**Responses to Public Comments
Submitted on the Draft Regulatory Guide
for Evaluation of Electromagnetic and
Radio-Frequency Interference in Safety-
Related I&C Systems
(DG-1029)**

September, 1998

**U.S. NUCLEAR REGULATORY COMMISSION
OFFICE OF NUCLEAR REGULATORY RESEARCH
Division of Systems Technology
Control, Instrumentation, and Human Factors Branch**

Figure 1 Comparison of low-frequency conducted susceptibility envelopes

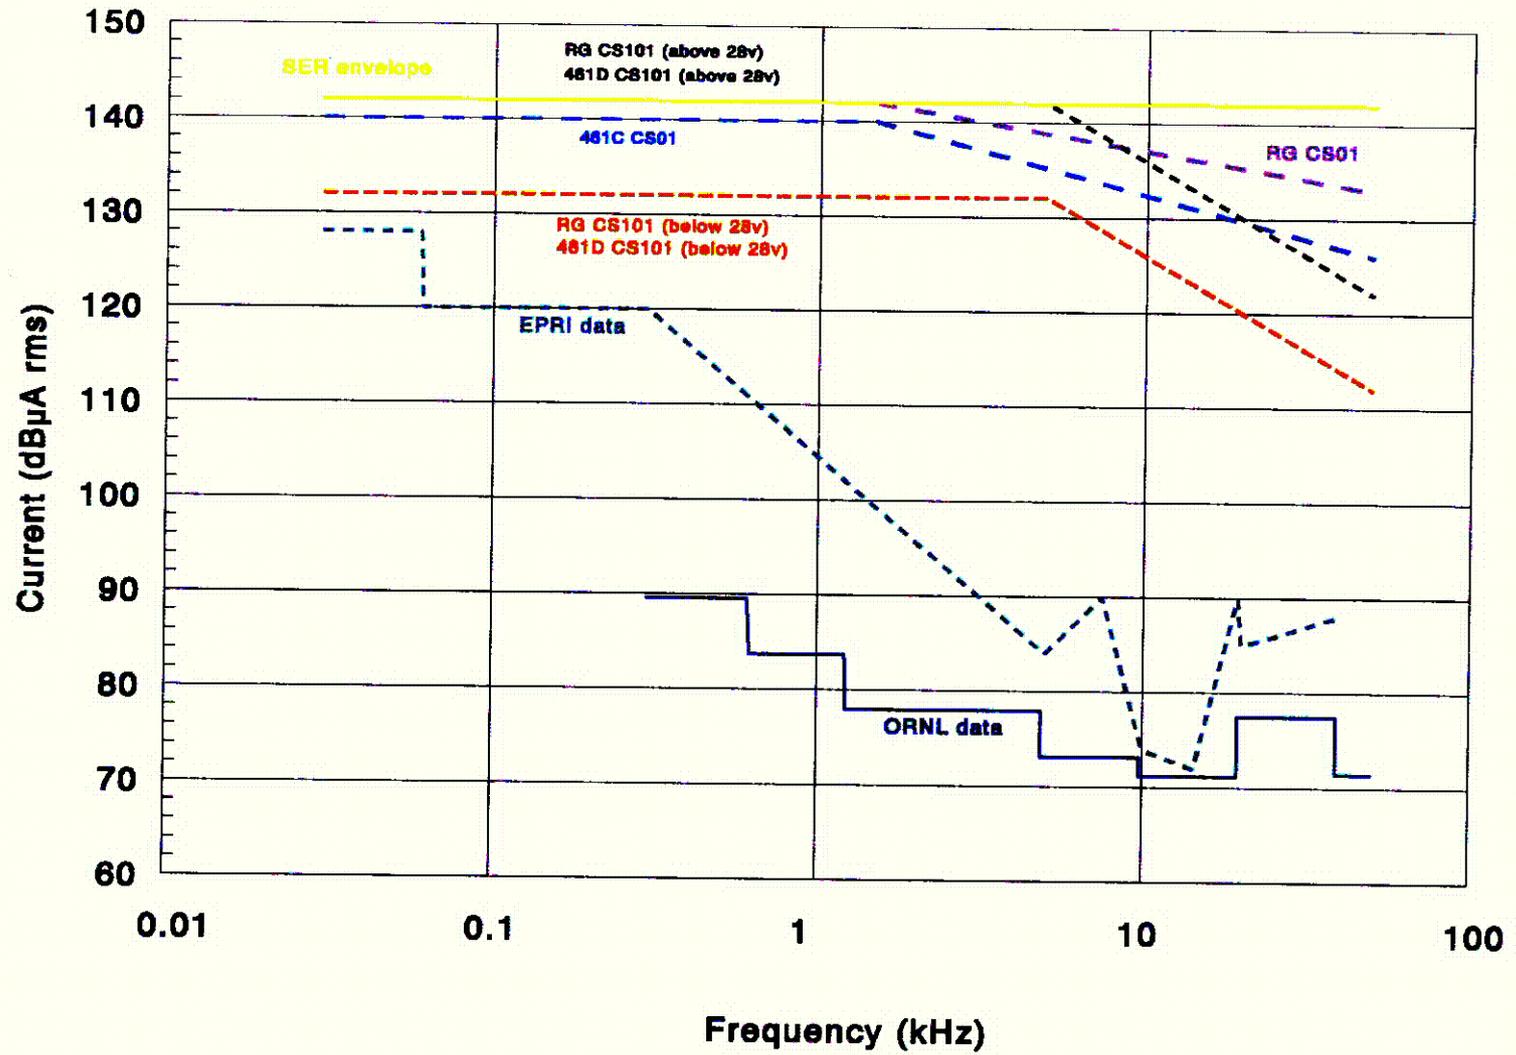
Figure 1 provides a comparative plot of the RG (i.e., DG-1029) envelopes for CS101 and CS01, the baseline MIL-STD envelopes, the corresponding envelope endorsed by the SER on EPRI TR-102323, and the plant emissions data presented in NUREG/CR-6436 and EPRI TR-102323. The RG and MIL-STD envelopes are converted from voltage to current for comparative purposes based on an assumption of 0.5 Ω impedance. It is seen that the RG and SER envelopes are similar in level. The most notable exception is the less restrictive RG envelope for equipment with source voltages at or below 28 V. As can be observed from the plot, this envelope only provides a 4 dB μ A margin above the highest measured plant emissions data reported in EPRI TR-102323. However, in the frequency range below 120 Hz, the 4 dB margin is judged to be sufficient for two reasons. First, the starting frequency for testing of ac powered equipment is specified to be the second harmonic so the ac limit does not apply over the frequency range with the 4

dB margin. Second, although the envelope does apply over the frequency range with the 4 dB margin for dc powered equipment, the bounding plant data resulted from ac powered equipment according to EPRI so adequate margin for dc powered equipment is probable.

Figure 2 Comparison of high-frequency conducted susceptibility envelopes

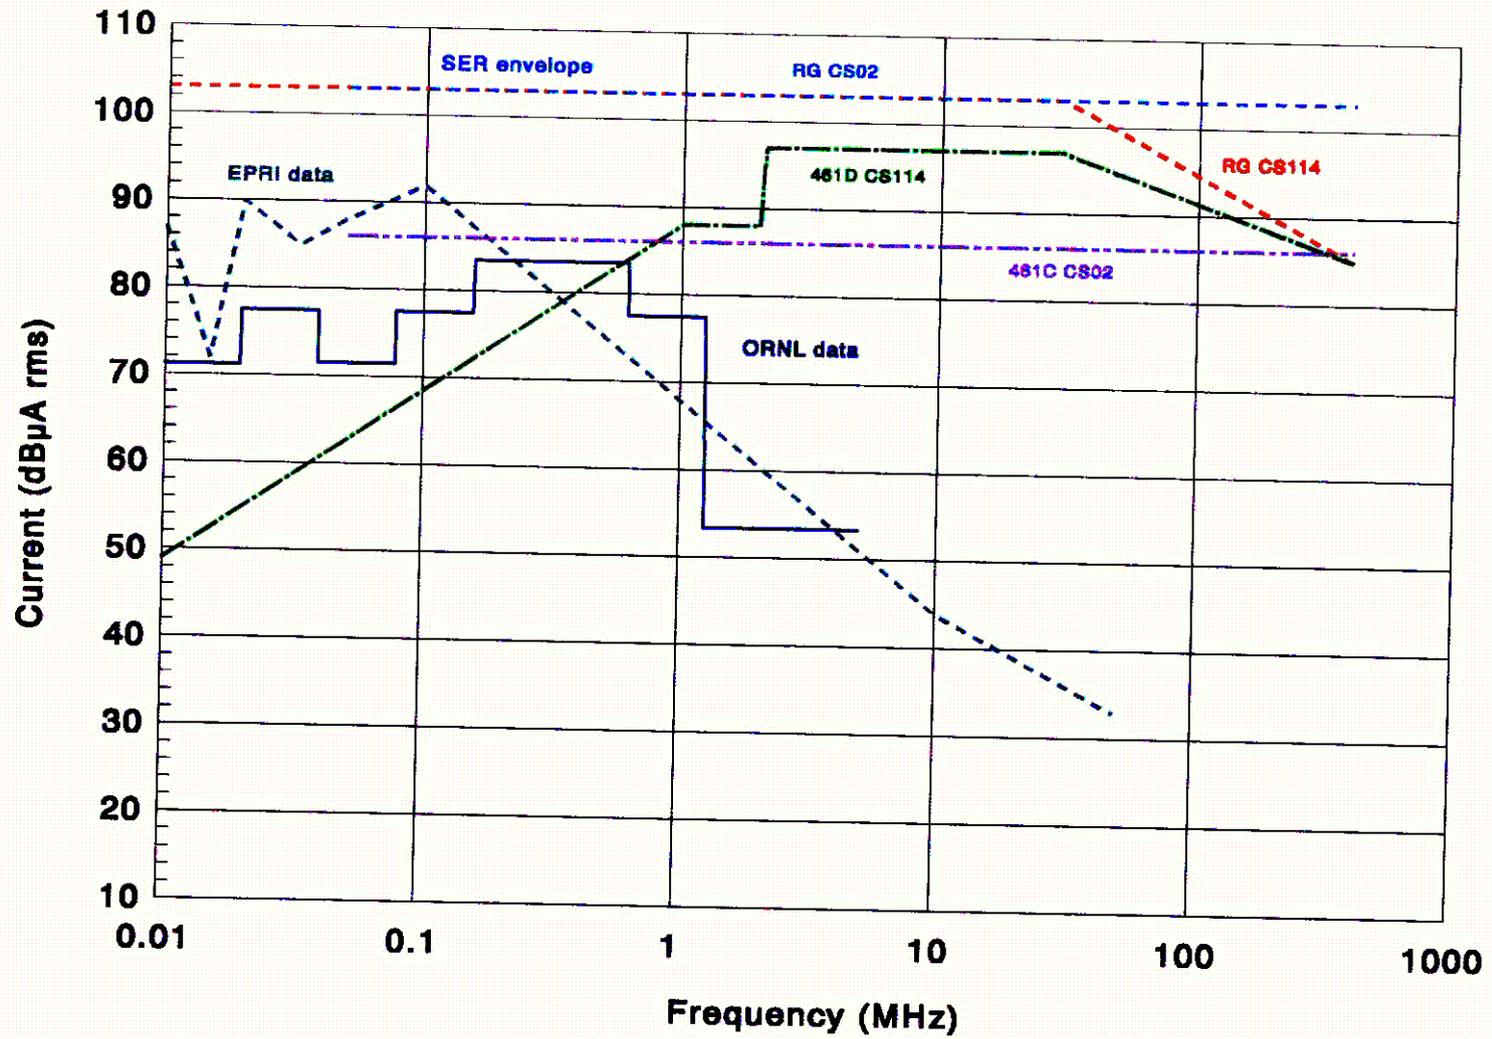
Figure 2 provides a comparative plot of the RG (i.e., DG-1029) envelopes for CS114 and CS02, the baseline MIL-STD envelopes, the corresponding envelope endorsed by the SER on EPRI TR-102323, and the plant emissions data presented in NUREG/CR-6436 and EPRI TR-102323. The RG and MIL-STD envelopes for CS02 are converted from voltage to current for comparative purposes based on an assumption of 50 Ω impedance. The conflict between the MIL-STD emissions envelopes and the plant emissions data is clearly seen. For this reason, the RG envelopes are adjusted from their MIL-STD basis. It is also seen that the RG and SER envelopes are similar in level. The most notable exception is the less restrictive RG envelope CS114 above 30 MHz. This difference

Figure 3 Comparison of low-frequency radiated susceptibility envelopes

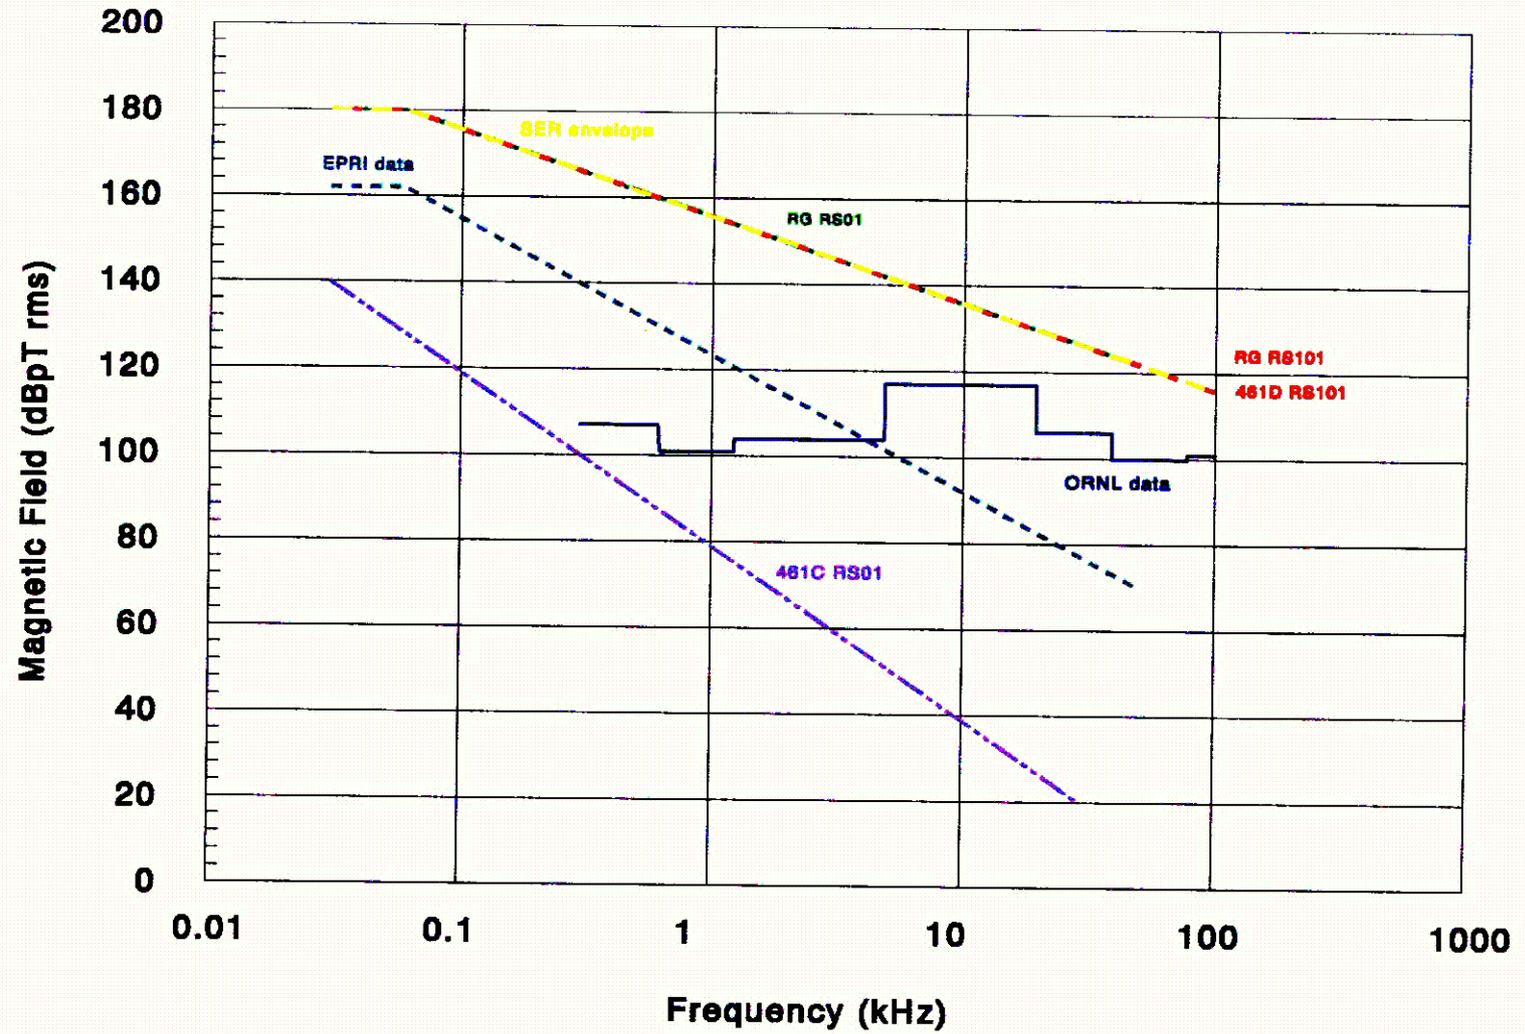
Figure 3 provides a comparative plot of the RG (i.e., DG-1029) envelopes for RS101 and RS01, the baseline MIL-STD envelopes, the corresponding envelope endorsed by the SER on EPRI TR-102323, and the plant emissions data presented in NUREG/CR-6436 and EPRI TR-102323. The conflict between the MIL-STD emissions envelopes for RS01 and the plant emissions data is clearly seen. For this reason, that RG envelope is adjusted from its MIL-STD basis. It is also seen that the RG and SER envelopes are identical.

Figure 4 Comparison of high-frequency radiated susceptibility envelopes

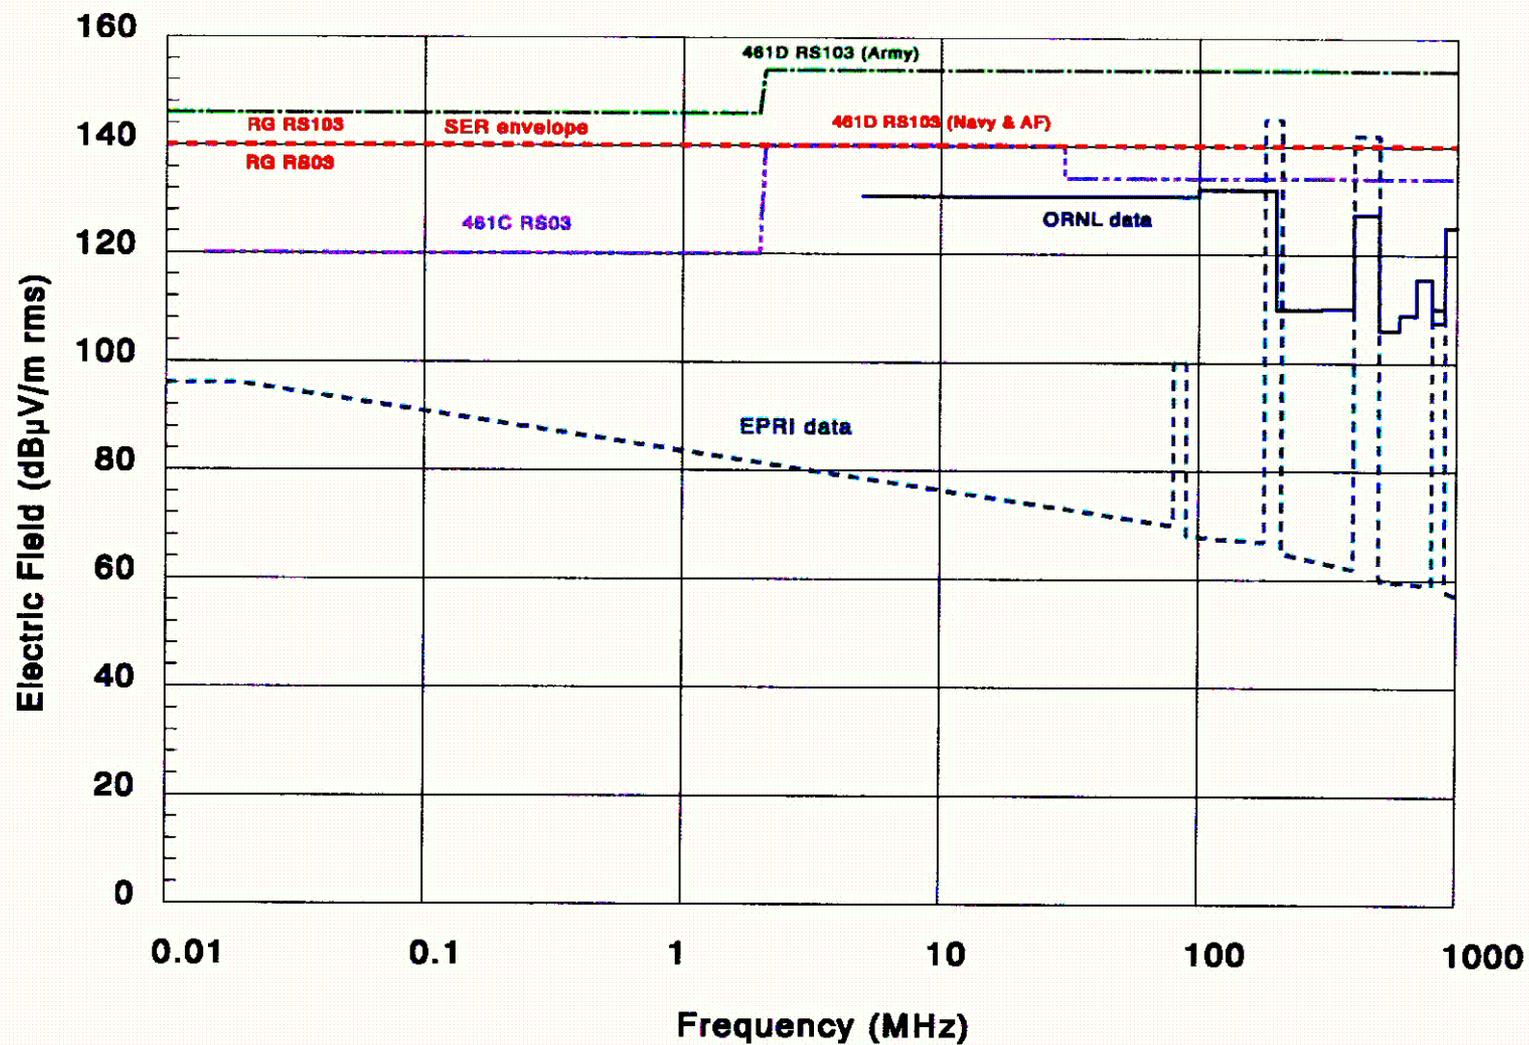
Figure 4 provides a comparative plot of the RG (i.e., DG-1029) envelopes for RS103 and RS03, the baseline MIL-STD envelopes, the corresponding envelope endorsed by the SER on EPRI TR-102323, and the plant emissions data presented in NUREG/CR-6436 and EPRI TR-102323. The MIL-STD 461D RS103 envelope for Army ground facilities is shown to illustrate difference that can result if administrative controls are not in place. The RG envelope is identical to the MIL-STD envelope for Navy and Air Force facilities. The conflict between the MIL-STD emissions envelopes for RS03 and the plant emissions data is clearly seen. For this reason, that RG envelope is adjusted from its MIL-STD basis. It is also seen that the RG and SER envelopes are identical.

Figure 5 Comparison of low-frequency conducted emissions envelopes

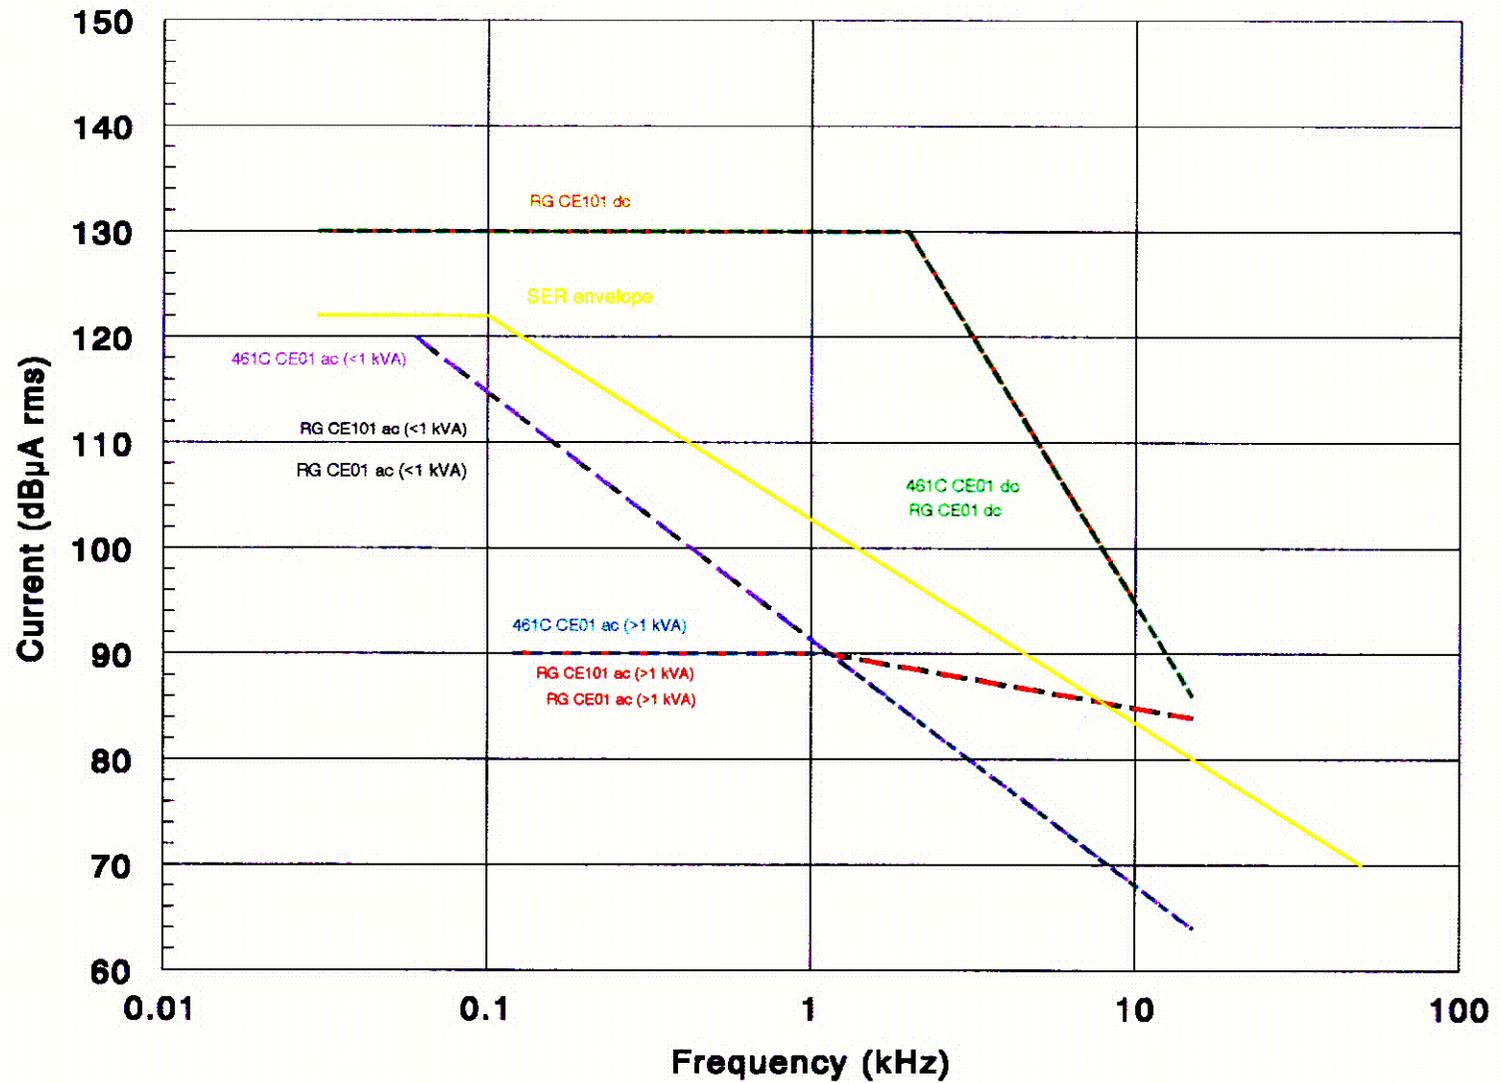
Figure 5 provides a comparative plot of the RG (i.e., DG-1029) envelopes for CE101 and CE01, the baseline MIL-STD envelopes, and the corresponding envelope endorsed by the SER on EPRI TR-102323. The envelopes for ac power leads are less restrictive than the MIL-STD envelopes in the higher frequency band (> 1.15 kHz) because of adjustments to promote consistency between the conducted emissions operating envelopes at 10 kHz for CE101 and CE102 and at 15 kHz for CE01 and CE03. The RG emissions envelope for dc power leads is less restrictive than the corresponding SER emissions envelope. The RG emissions envelopes for ac power leads are somewhat more restrictive than the corresponding SER emissions envelope. Nevertheless, the power quality basis for ac-power-lead emissions envelopes provides an appropriate foundation for the RG envelopes.

Figure 6 Comparison of high-frequency conducted emissions envelopes

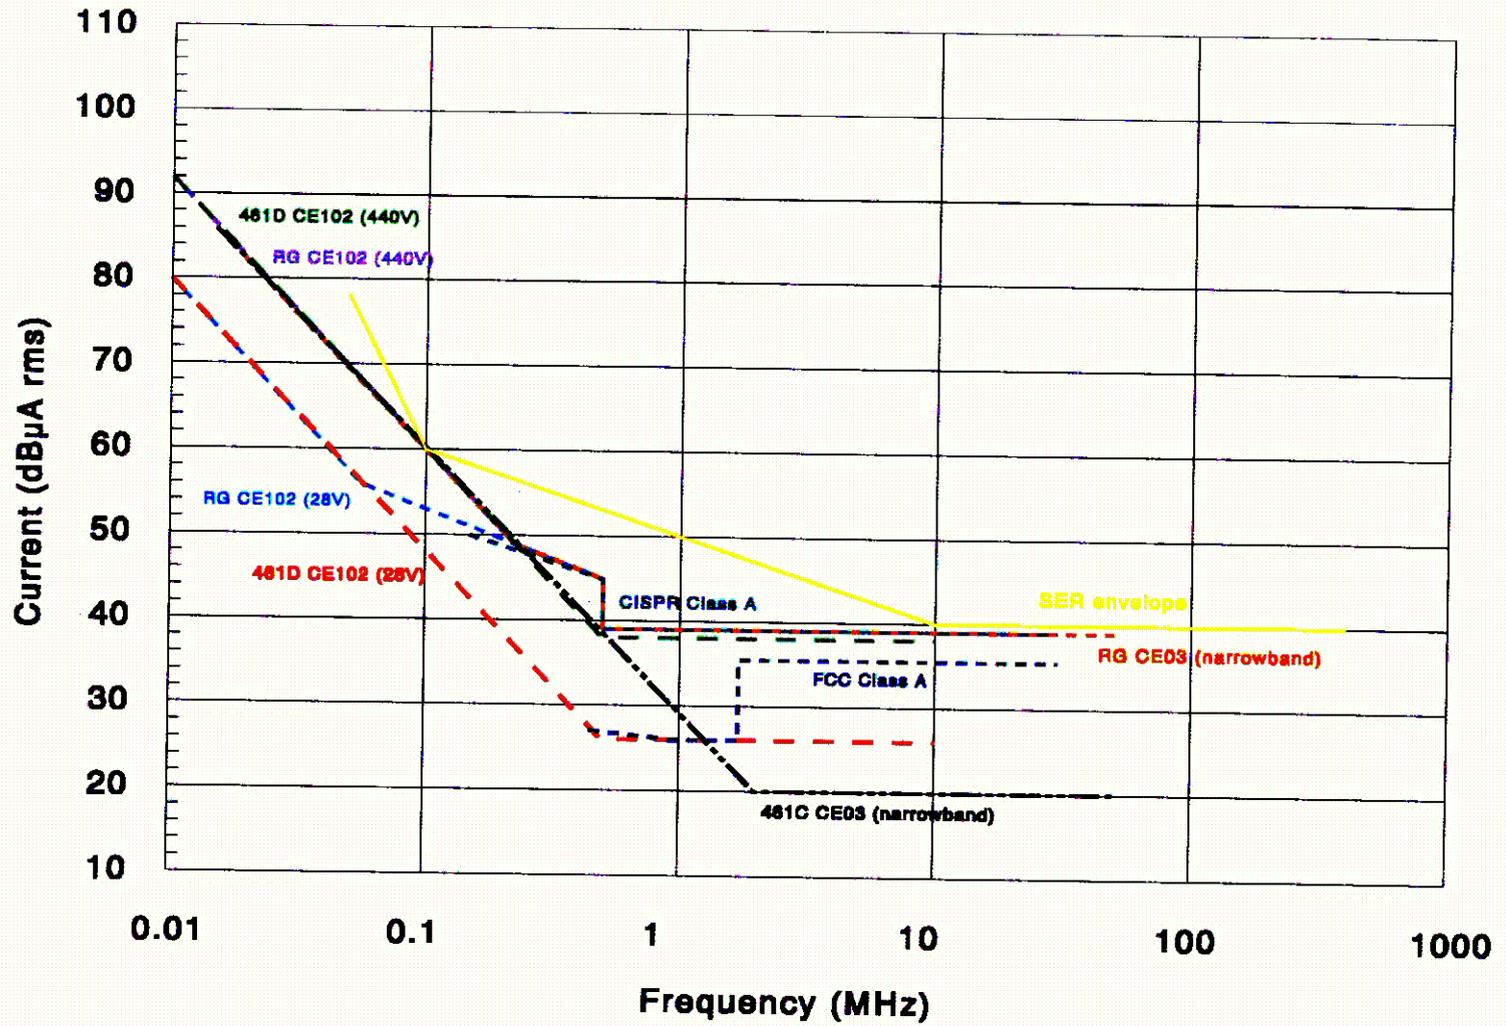
Figure 6 provides a comparative plot of the RG (i.e., DG-1029) envelopes for CE102 and CE03, the baseline MIL-STD envelopes, the corresponding envelope endorsed by the SER on EPRI TR-102323, and the Class A equipment emissions limits for CISPR and FCC Part 15. The RG and MIL-STD envelopes for CE102 are converted from voltage to current for comparative purposes based on the test apparatus impedance established in MIL-STD 462D. The CISPR and FCC limits are converted from voltage to current for comparative purposes based on the test apparatus impedance defined for those test methods. The RG envelopes completely encompass the CISPR and FCC conducted emissions limits. The RG envelopes are slightly more restrictive than the corresponding SER envelope. Nevertheless, the power quality basis for the low frequency component of the emissions envelopes and the industrial emissions limit basis for the high frequency component of those envelopes provide an appropriate foundation for the RG envelopes for CE102 and CE03.
